**TOWN OF CARMEL
PLANNING BOARD**

PLANNING BOARD AGENDA
MARCH 29, 2017

RE: Day Road LLC. Storage Building : 20 Day Road, Carmel NY

RE: Baldwin Subdivision
Route 6
Tax Map No. 86.11-1-1

Final Subdivision Plat
known as the
Baldwin Subdivision
Situate in the
Town of Carmel
Putnam County, New York
September 28, 2016
Revised: January 11, 2017
Revised: February 8, 2017
Revised: March 16, 2017

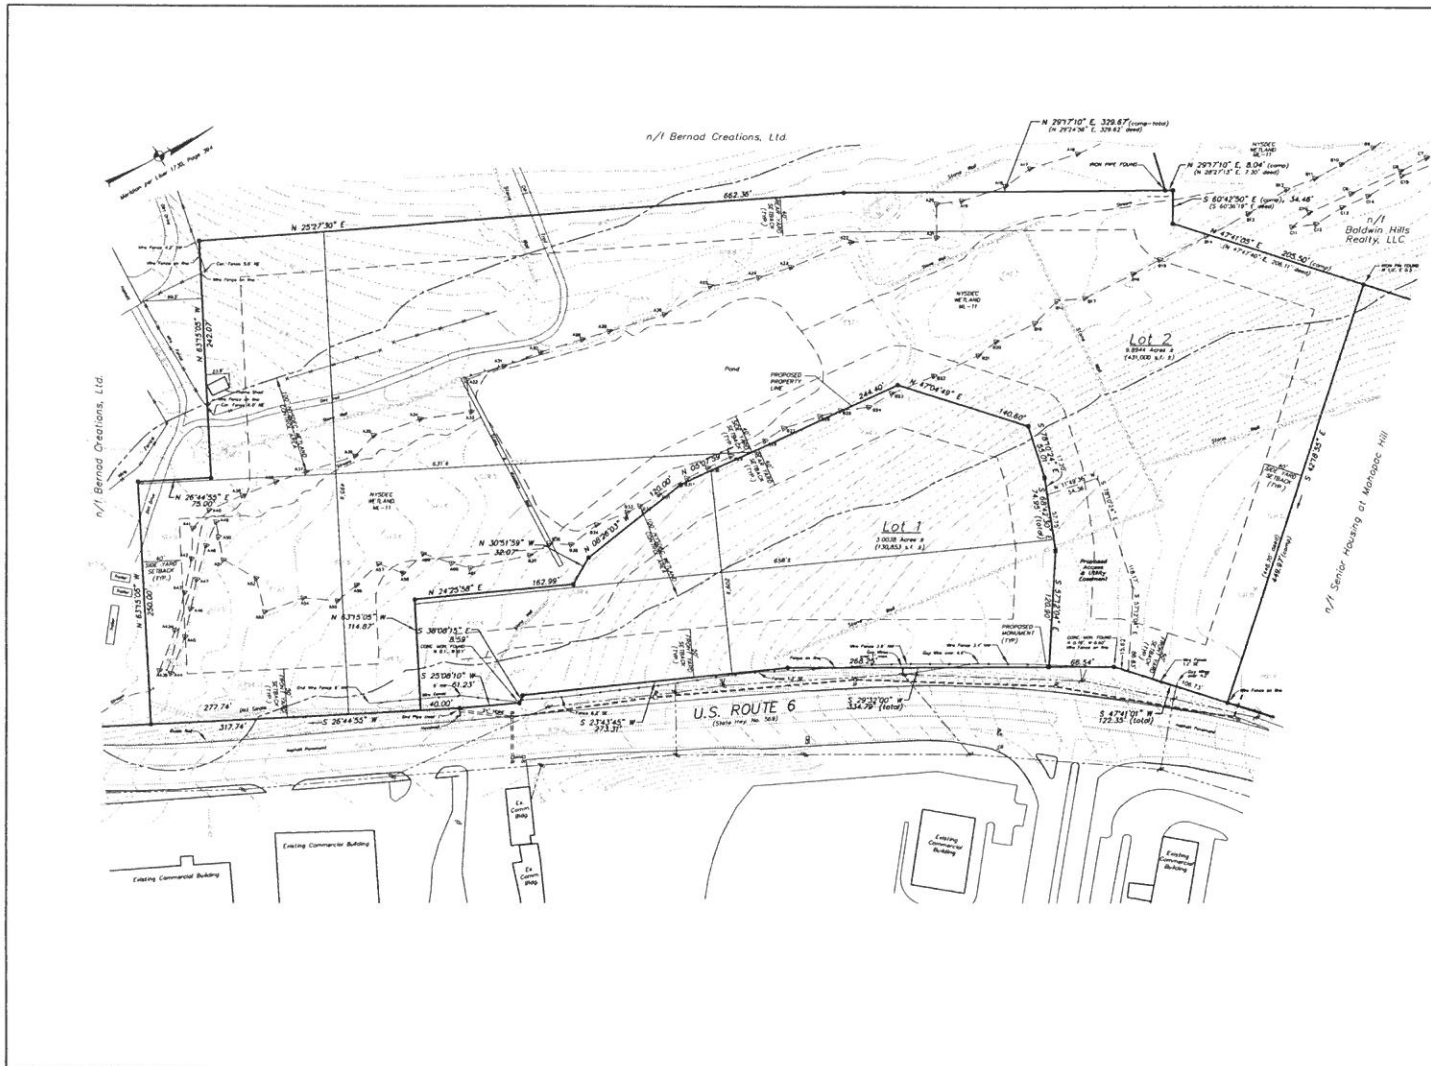
Memorandum from Michael G. Carnazza, Director of Code Enforcement, dated March 7, 2017:

Memorandum from Richard J. Franzetti, P.E., Town Engineer, dated February 22, 2017:

Memorandum from Patrick Cleary, AICP, CEPPP LED, AP, dated March 8, 2017:

1. As noted, the applicant chooses to resubdivide the subject property into two complying lots.
2. The lot width and lot depth lines have been added to the plat as requested.
3. It is understood that the site plan associated with Putnam County Savings Bank (PCSB) can be approved, subject to the filing of the subject subdivision plat.

1. The subdivision application proposes no improvements to the site and as such, certain of the referrals don't appear to be necessary.
2. The subdivision application does not propose any improvements and therefore permits from the agencies listed are not required. It is noted that the Putnam County Department of Health (PCDOH), will have to sign the subdivision plat, based on a non-jurisdictional provision.

3. A Stormwater Pollution Prevention Plan (SWPPP) is not required for the subdivision, but in fact is associated with the site plans which are not the subject of this subdivision application.

4. There are no public improvements associated with the subdivision.
5. The current subdivision plan does not propose to reserve any area as open space.

6. There are no stormwater improvements associated with the subdivision and therefore bonds and maintenance guarantees are not applicable to the subdivision.

1. The lot area associated with this application is consistent with previous applications. Also, note the adjacent 172-acre parcel is not involved in this subdivision.
2. It is acknowledged that a large portion of the property is constrained by the onsite pond and NYSDEC wetland.

3. As noted, the reduction in size of the PCSB parcel does not impact its compliance with zoning and its proposed site plan improvements.
4. The applicant continues in discussions with the County regarding the access to the adjacent Kohler Senior Center.
5. The applicant acknowledges the requirements of maintenance to the pond.
6. There is no proposal with the current application for a conservation easement on the environmentally constrained portion of the parcel.
7. It is not known if the modified subdivision layout would affect the County trailway, since details of its design are not yet established.
